**Subject: Beaver Valley Power Station, Unit No. 1
Docket No. 50-334, License No. DPR-66
Response to Request for Additional Information in Support of
License Amendment Request No. 328, Revised Steam Generator
Inspection Scope for One Cycle of Operation**

**REQUEST FOR ADDITIONAL INFORMATION
BEAVER VALLEY POWER STATION UNIT 1 (BVPS-1)
ONE-CYCLE APPROVAL TO USE W* METHODOLOGY
FOR STEAM GENERATOR (SG) TUBE INSPECTION
DOCKET NO. 50-334**

Figure 1

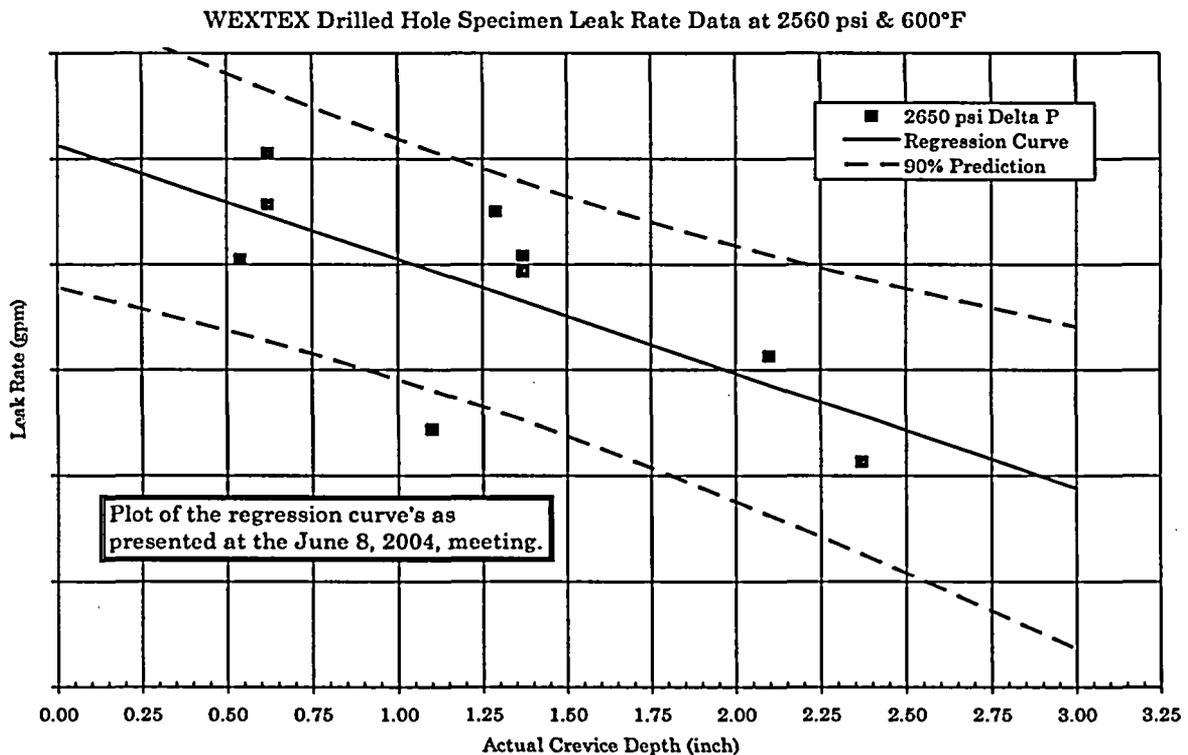
Slide 19 of the June 8, 2004 presentation (ADAMS No. ML042010038) presented a linear 1st order regression curve of the common logarithm of the leak rate as a function of the actual crevice depth. The regression analysis included only the data obtained at an intended differential pressure of 2650 psi; however, the last bullet of slide 18 noted that the regression lines for intended differential pressures of 1620, 2000, and 2650 were not statistically different, thus, all of the data could have been included in the regression analysis. Moreover, the actual contact pressure for each specimen was calculated. Thus, a model of the leak rate as a function of crevice length could be expanded to include the contact pressure as,

whereas the contact pressure was not included in the regression results presented at the June 8 meeting. It was noted during the meeting that a significant reduction in the predicted leak rate would be realized if the pressure term were added. The figure from the meeting presentation is included herein as Figure 1. The results from the preliminary analysis of the grouped data are presented in Figure 2. A significant reduction of the predicted leak rate is readily apparent relative to the Figure 1 regression results.

Review of the specimen contact pressure calculation indicates that WEXTEx pressure was not included. However, the corresponding tube depths for application of the leak rates based on sample contact pressure remain bounded by the elevation application in the LAR. The calculation of tube contact pressures in Table 4.3-9 of WCAP-14797 include a crevice secondary side pressure of 800 psi. The calculation of

During the discussion with representatives of the NRC staff on August 26, 2004, it was noted that the contact pressures used for the presented correlation did not include any reduction for the fluid pressure in the crevice. Moreover, the contact pressures noted for the SG do include a reduction of the contact pressure to account for a postulated 800 psi fluid pressure in the crevice. This means that for a given leak rate, a higher contact pressure is deemed to be needed using the analysis results. Conversely, for a given calculated contact pressure the associated predicted leak rate will be higher than indicated by the test data. In summary, the exclusion of the crevice pressure for the test data and the inclusion of the crevice pressure for leak rate prediction purposes is conservative.
